Transmission Oil Cooler Lines Rubbing

- GEN 5 Cascadia WST 47x 49x

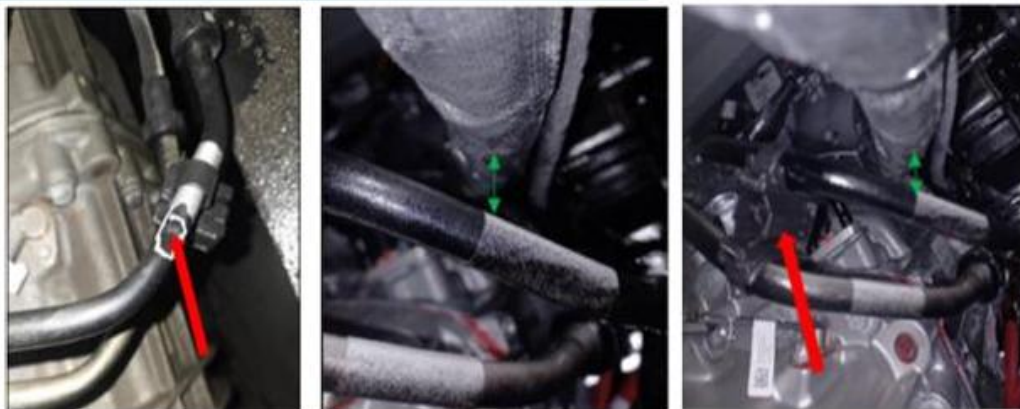
- Nylon Transmission oil cooler lines if not festooned correct can rub & chafe & eventually leak at low mileage. If caught early, lines are replaced. If not caught quickly the entire transmission often must be replaced.

- Plant work instruction was updated to address the routing requirements, Stating not to deviate or add any extra ties or clamps.
- Re-Training at the plants per the updated work instruction implemented & on going.

- LTCA Production - Plant Updates – Add Transmission Cooler lines to Standard Routing and Clipping Guidelines
- Verification 30/60/90 Day process audits to be complete by 8/15/26
